MEMO

DATE: February 4, 2022
TO: Portland Historic Landmarks Commission
FROM: Brandon Spencer-Hartle, Lora Lillard, and Cassie Ballew, BPS
CC: Hillary Adam, BDS and Dan Layden, PBOT
SUBJECT: Earl Blumenauer Bridge Belgian Block Deployment Request

SOUTH LANDING SITE PLAN

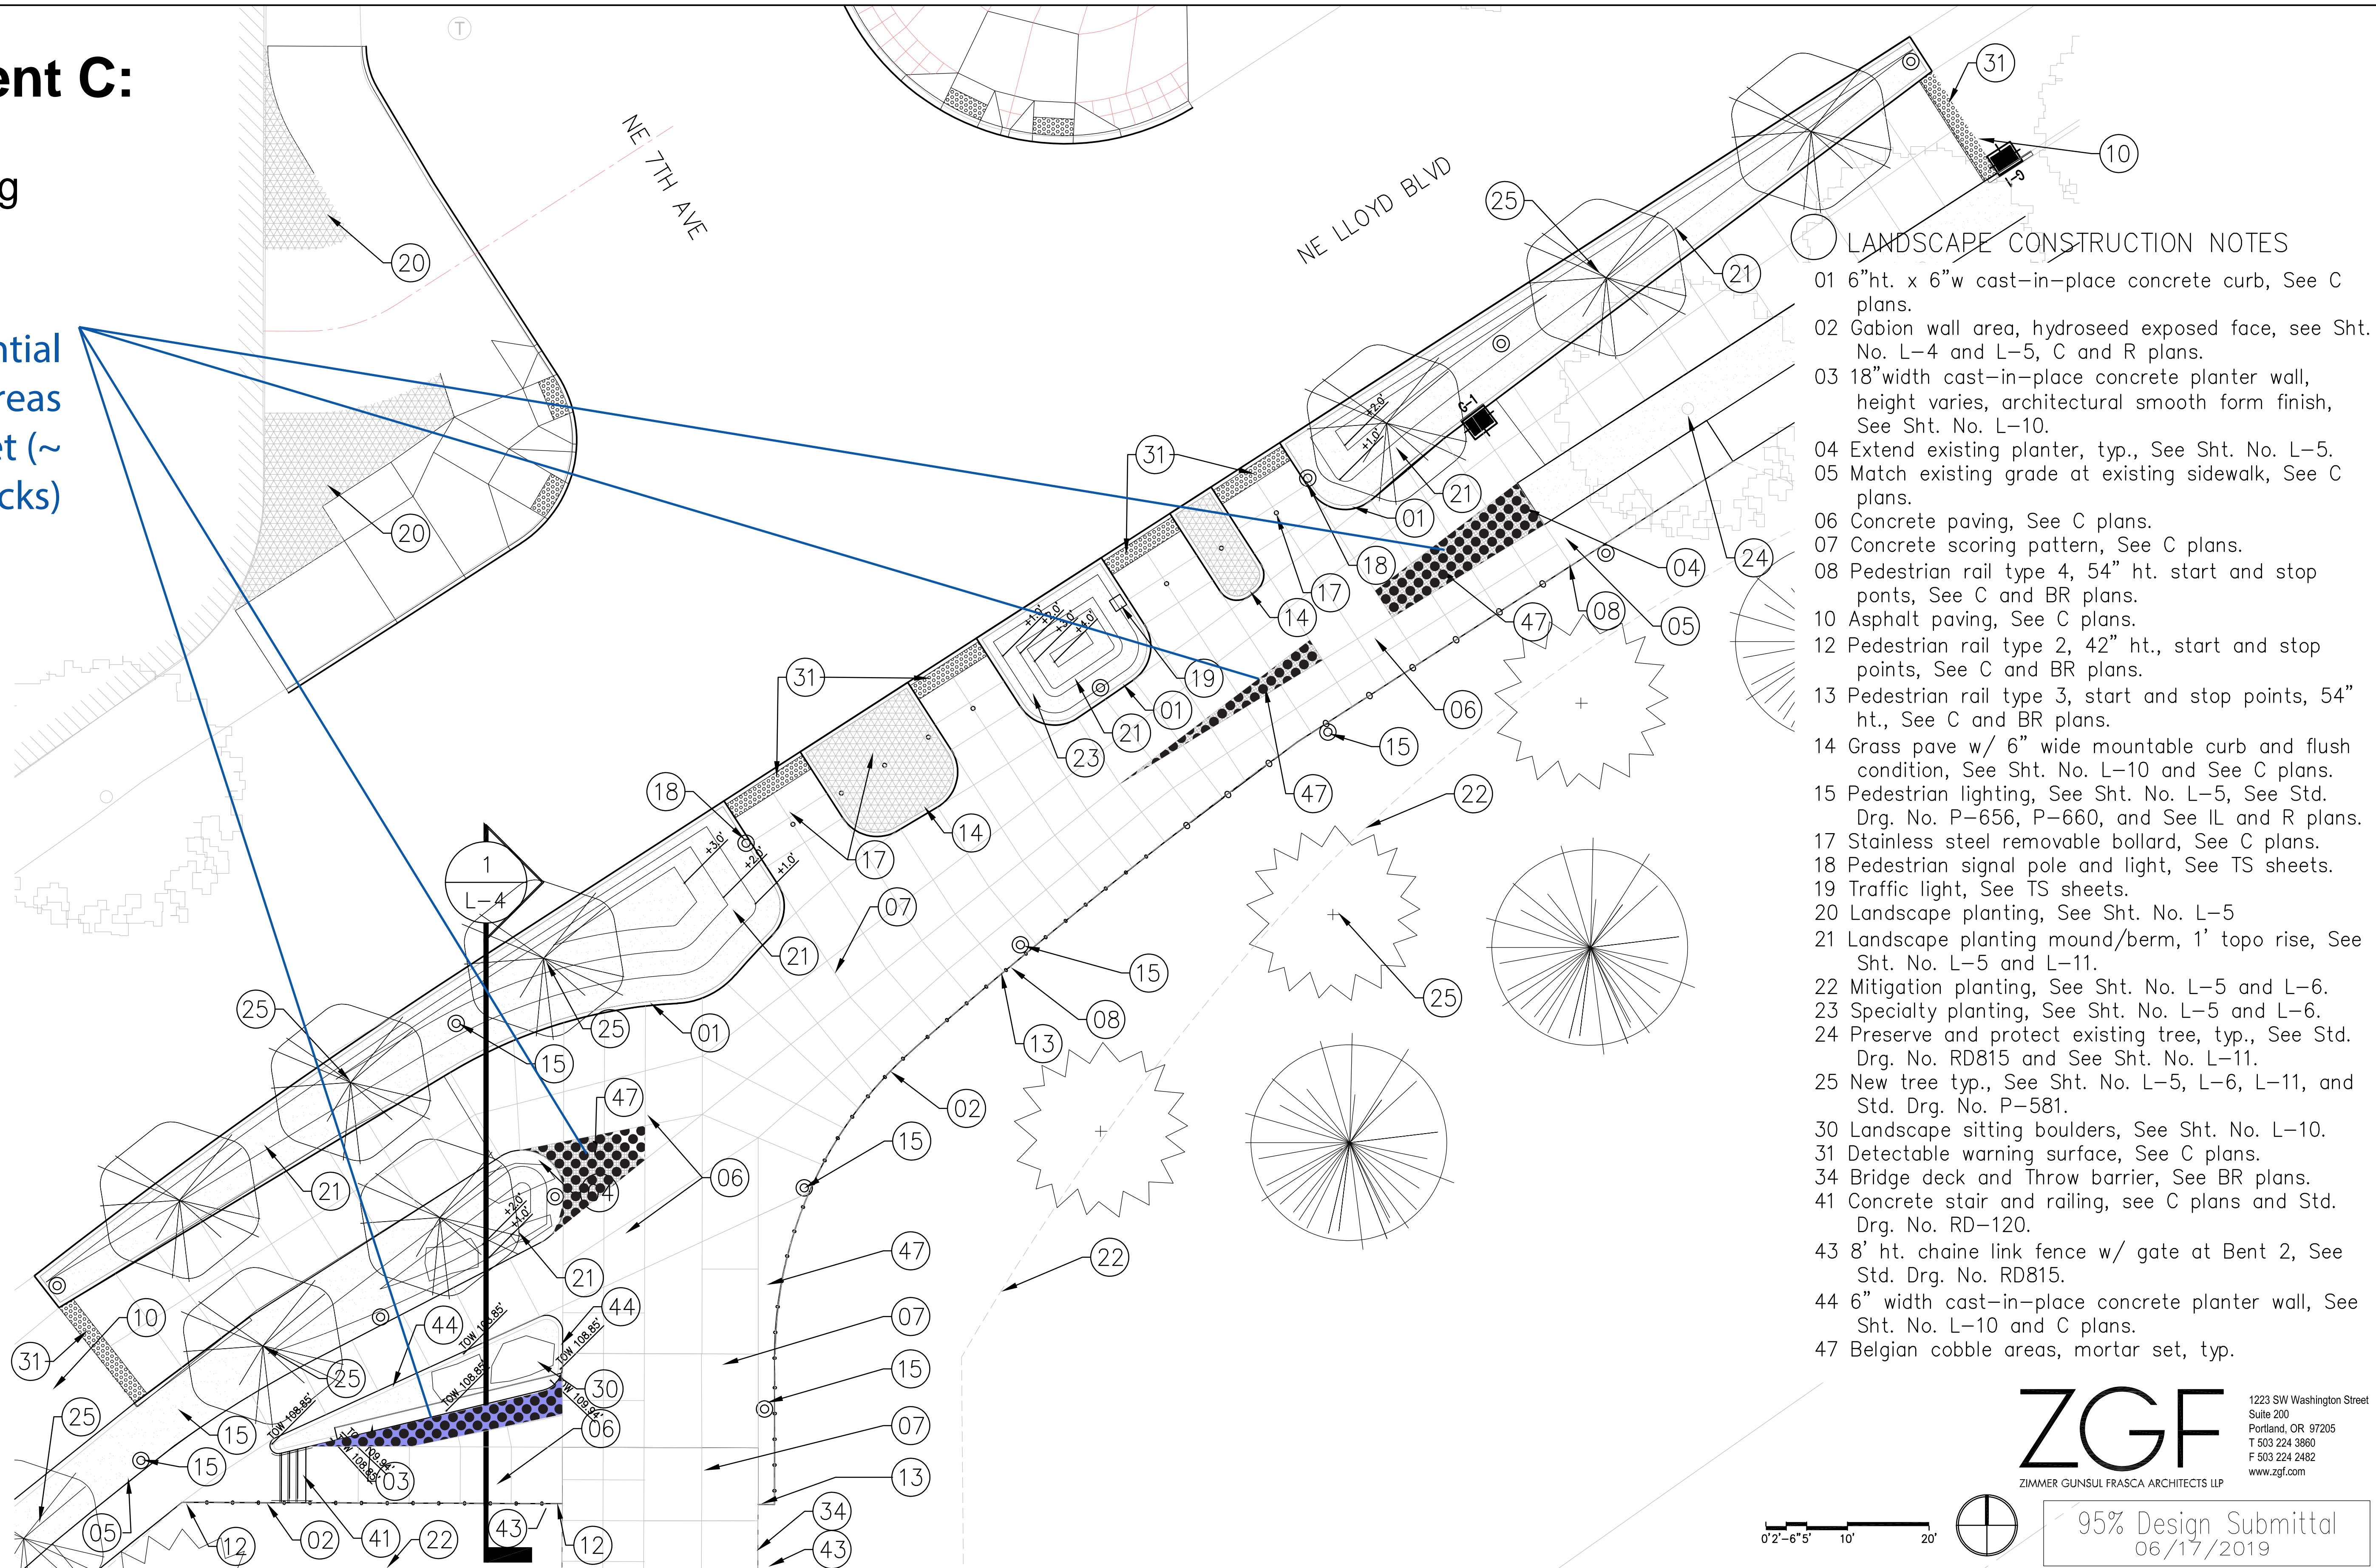
- **NORTH:** Belgian Blocks separate pedestrians and cyclists along Sullivan’s Gulch trail while also physically illustrating northeast-southwest flow.
- **SOUTH:** Belgian Blocks separate pedestrians and cyclists, as well as pedestrians and cars, moving in the direction of north-south flow and the curvature of NE Flanders.

1/4 SECTION
1n1e35
PROJECT NO.
T00638
SHEET NO.
L-2

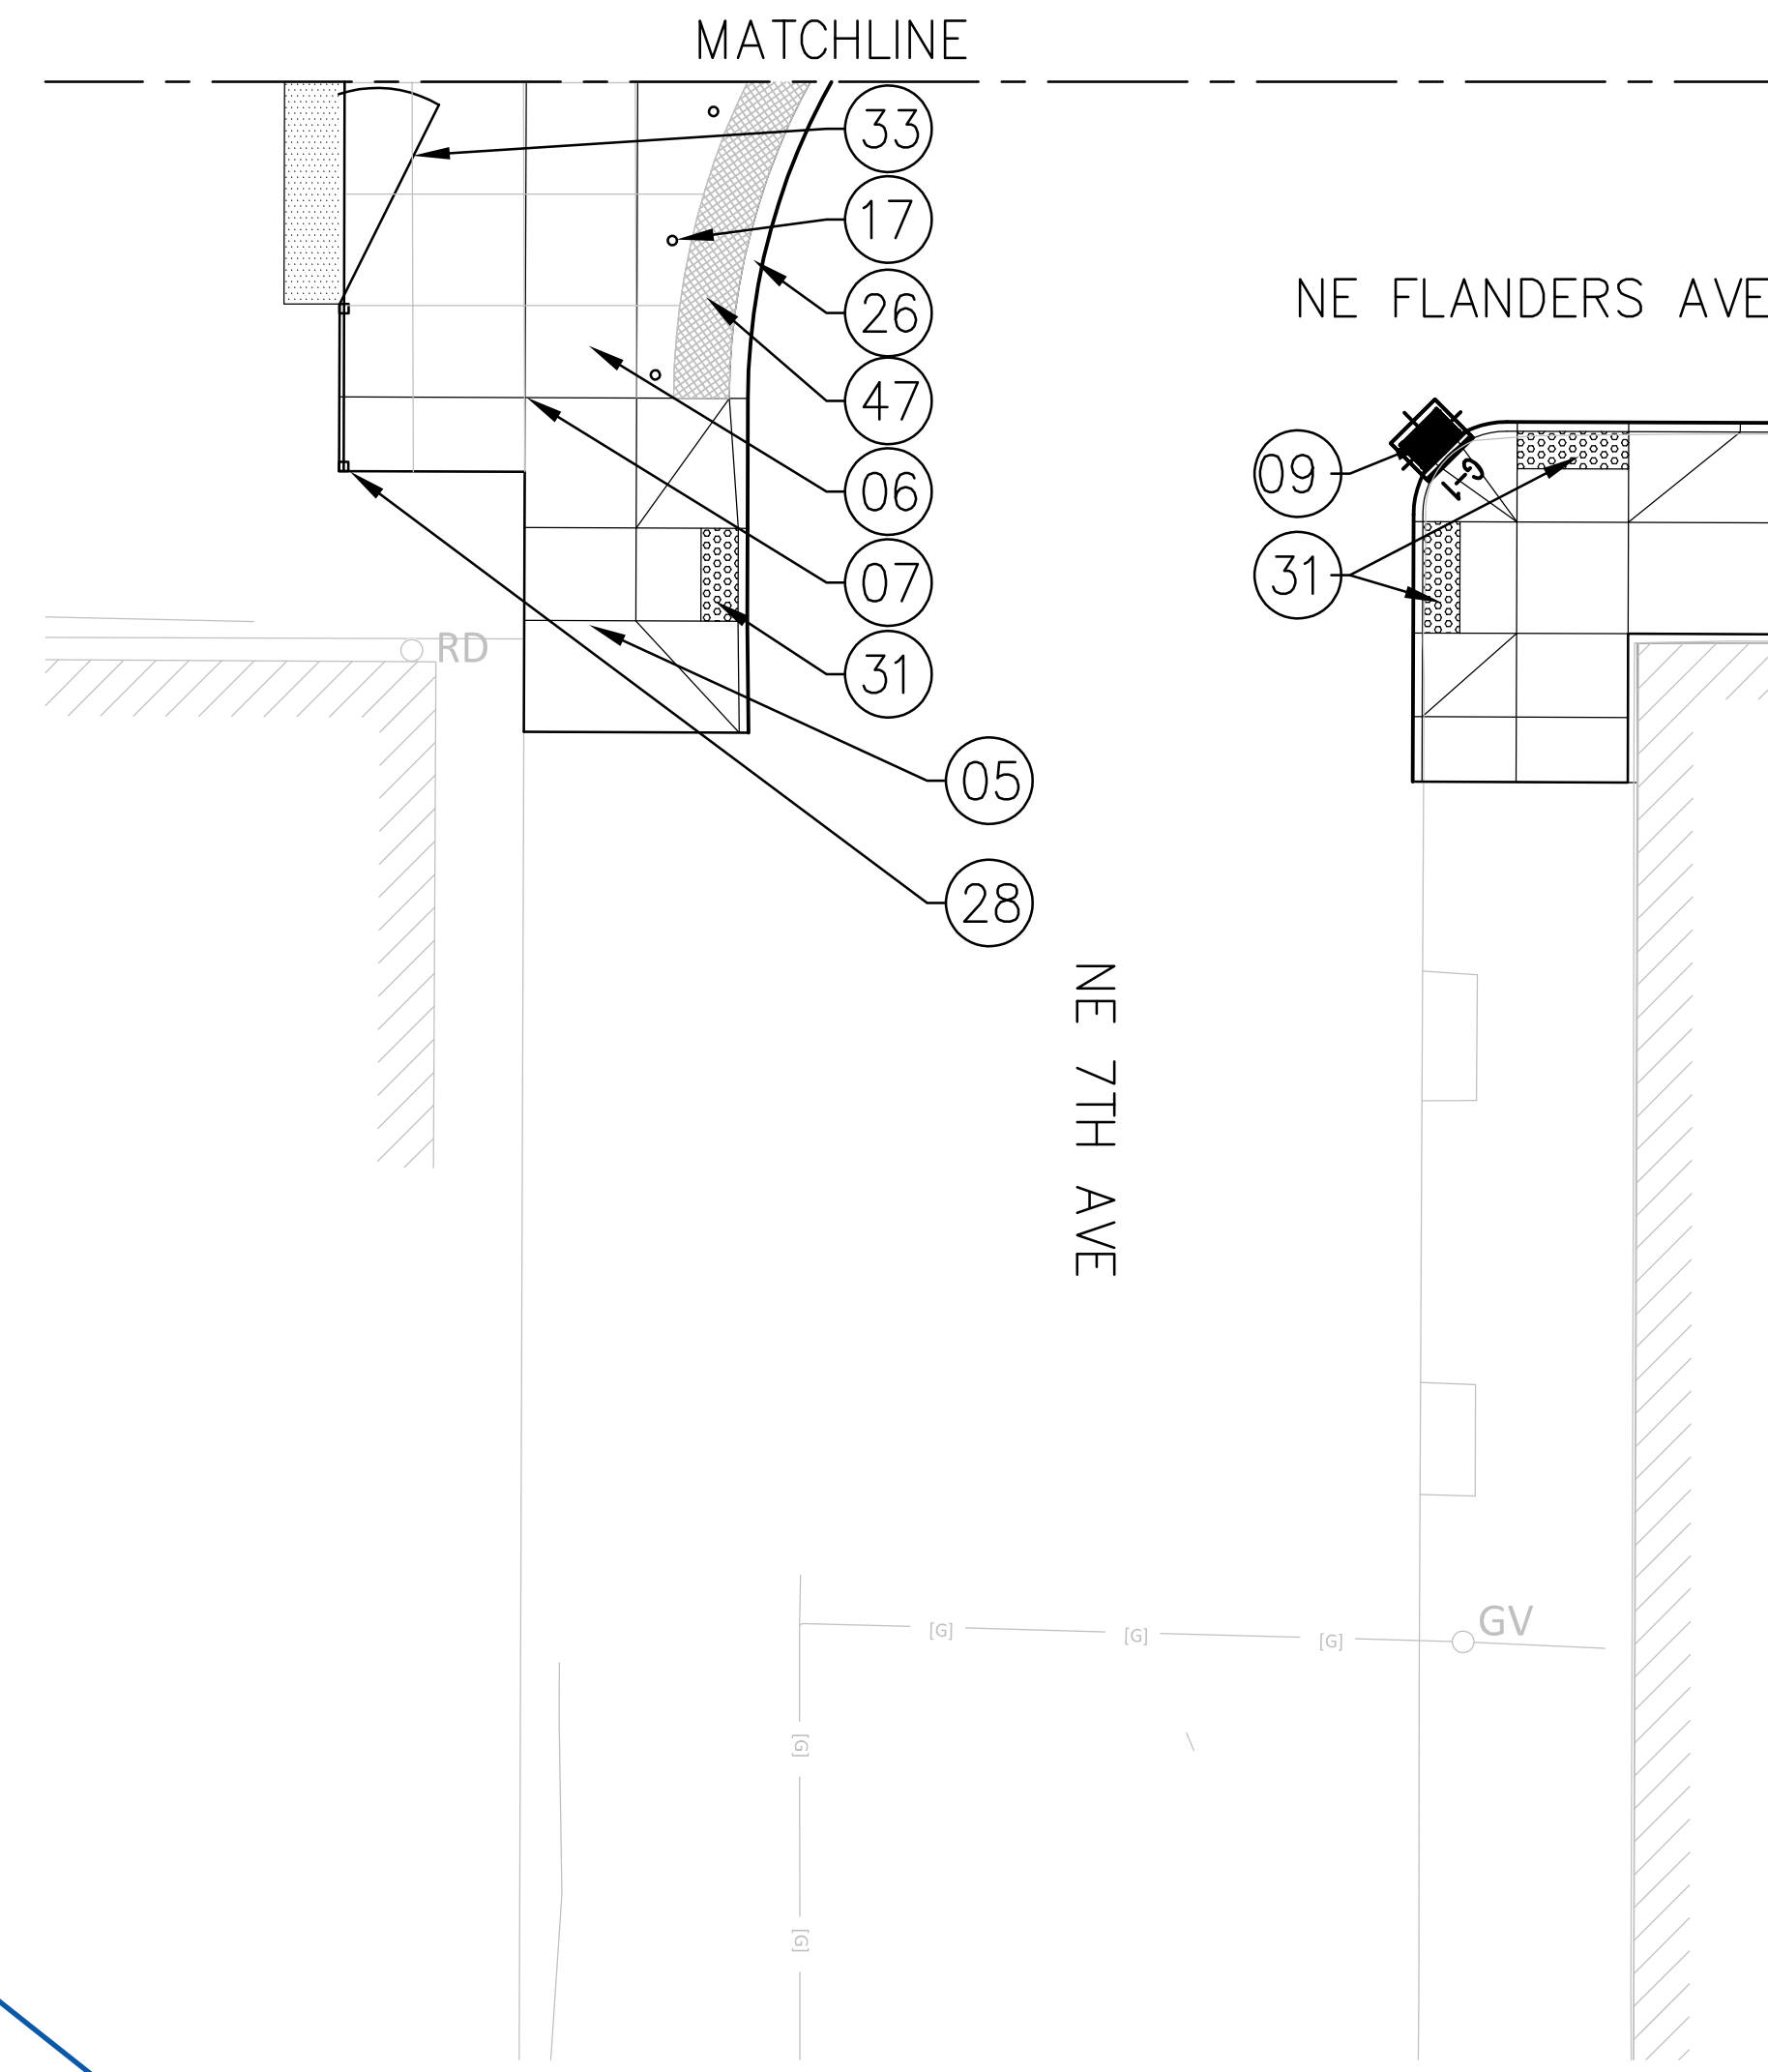
- **NORTH:** Option 2, plus an additional area that buffers pedestrians from the grade change within the planting area as pedestrians move east-west to and from the bridge itself.
- **SOUTH:** Option 2, plus an additional area along the eastern edge of a raised planting bed that buffers bicycles from the grade change and physically illustrates north-south flow.
